SERVICE BULLETIN 67

SUBJECT: TRIM SYSTEM INTERFERENCE BETWEEN CABLE DRUM AND TRIM CONTROL BOX HOUSING

APPLICATION: All Glasair II and Glasair III aircraft and Glasair Is that have been retrofitted with the Glasair II/III trim system

FIGURE (1)

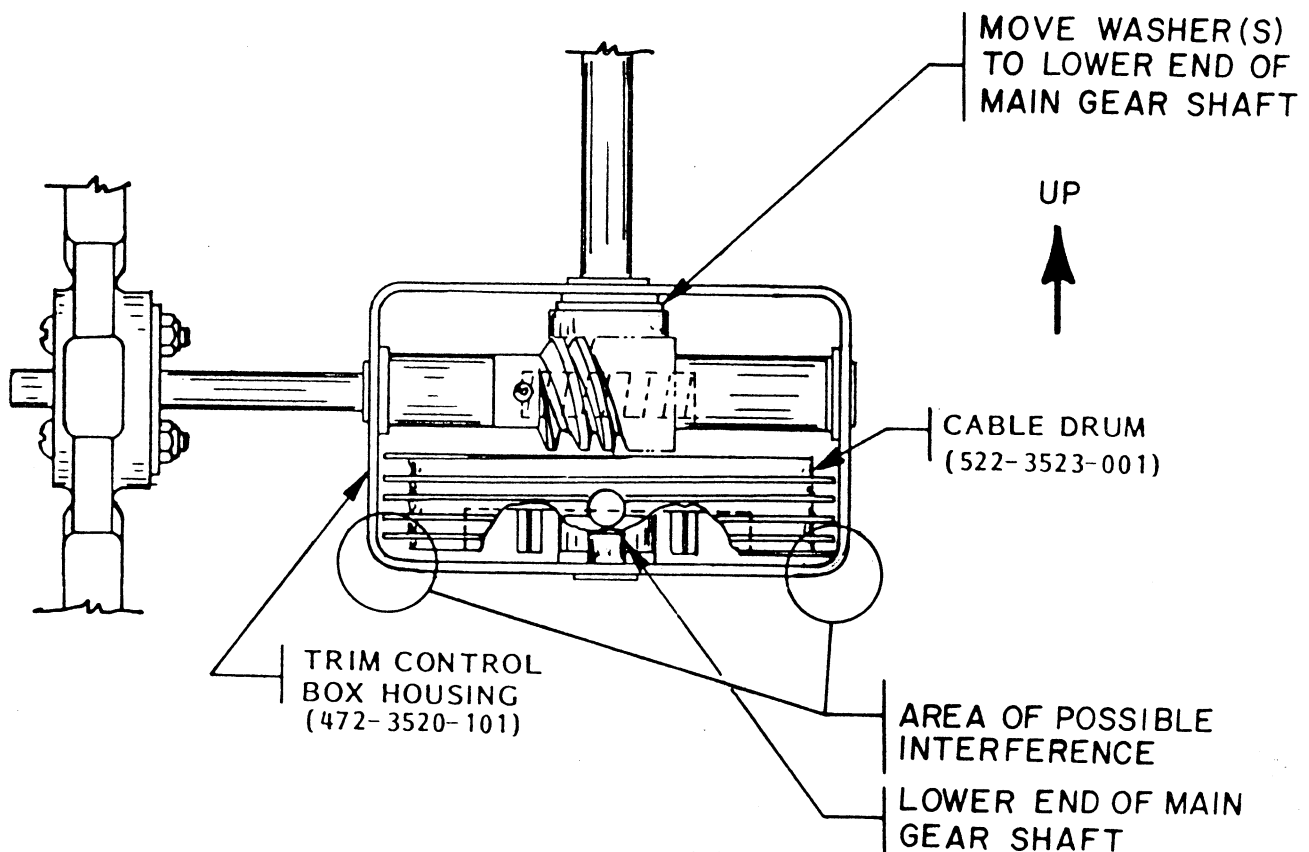
DESCRIPTION: The position of the cable drum (522-3523-001) results in contact between the lowest cable guide flange on the drum and the rounded lower corners of the trim control box housing (472-3520-101) when the drum is rotated to certain positions, as shown in FIGURE (1). Under extreme conditions this interference may make it impossible for the cable drum to rotate sufficiently to contact the stop pin on the cable housing, thus limiting full elevator trim movement.

SOLUTION: If a washer has been installed between the upper end of the main gear and the upper NAS77-4-06 bushing in the trim housing, move the washer to the lower end of the main gear shaft, between the NAS42DD8-12 spacer and the lower NAS77-4-06 bushing. This shifts the cable drum upward in the housing to provide better clearance and also improves the alignment of the main gear with the worm drive.
